TSG-RAN Meeting #12
Stockholm, Sweden, 12-15, June, 2001

RP-010331

Title: **Agreed CRs (R99 and Rel-4 Category A) to TS 25.211**

Source: **TSG-RAN WG1**

Figure 15: Frame structure for Primary Common Control Physical Channel

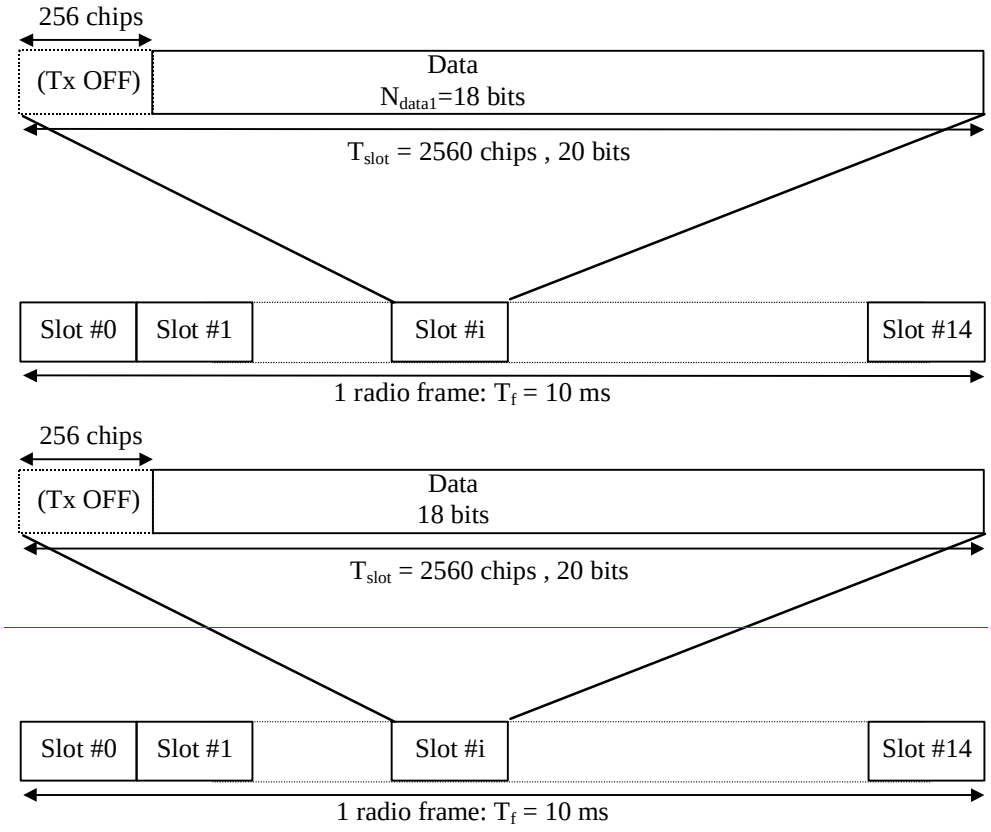
Reason for change:	⌘	The reference symbol from TS25.212 does not cover the case of P-CCPCH, S-CCPCH and PDSCH
Summary of change:	⌘	The number of data bits per downlink slot is always represented by N_{data1} and N_{data2}.
Consequences if not approved:	⌘	Inconsistency of the number of data bits per downlink slot happens in case of P-CCPCH, S-CCPCH and PDSCH.

Figure 15 shows the frame structure of the Primary CCPCH. The frame structure differs from the downlink DPCH in that no TPC commands, no TFCI and no pilot bits are transmitted. The Primary CCPCH is not transmitted during the first 256 chips of each slot. Instead, Primary SCH and Secondary SCH are transmitted during this period (see subclause 5.3.3.4).

Figure 15: Frame structure for Primary Common Control Physical Channel

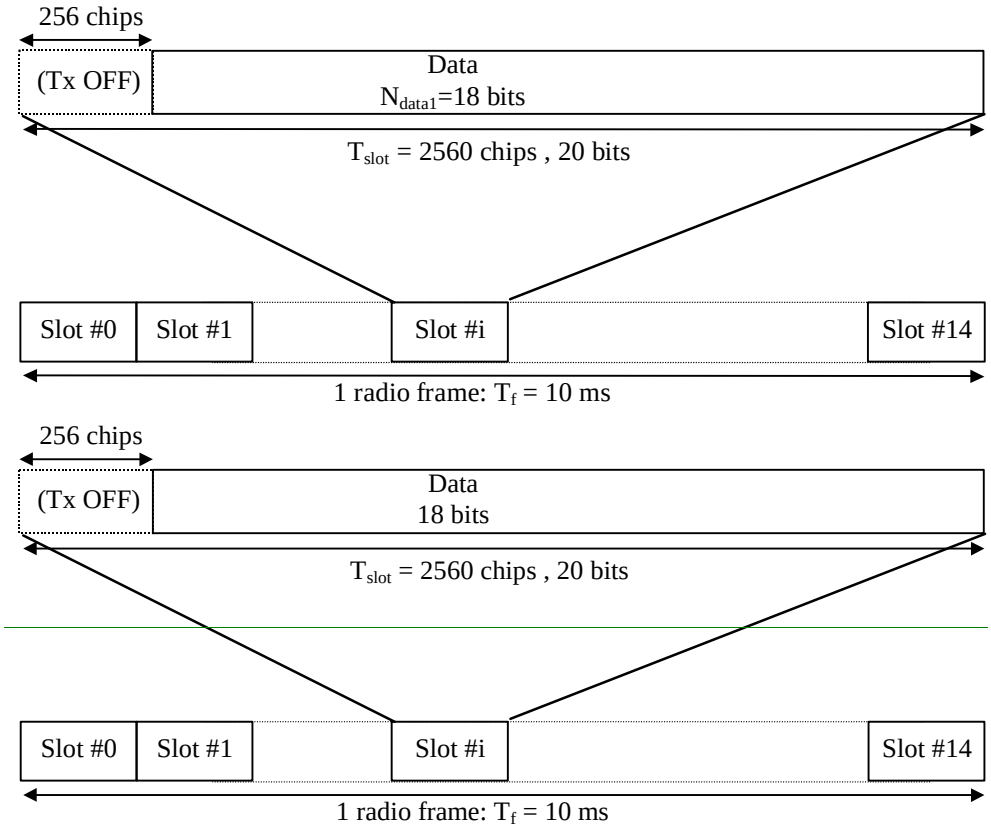
Reason for change:	⌘	The reference symbol from TS25.212 does not cover the case of P-CCPCH, S-CCPCH and PDSCH
Summary of change:	⌘	The number of data bits per downlink slot is always represented by N_{data1} and N_{data2}.
Consequences if not approved:	⌘	Inconsistency of the number of data bits per downlink slot happens in case of P-CCPCH, S-CCPCH and PDSCH.

Figure 15 shows the frame structure of the Primary CCPCH. The frame structure differs from the downlink DPCH in that no TPC commands, no TFCI and no pilot bits are transmitted. The Primary CCPCH is not transmitted during the first 256 chips of each slot. Instead, Primary SCH and Secondary SCH are transmitted during this period (see subclause 5.3.3.4).
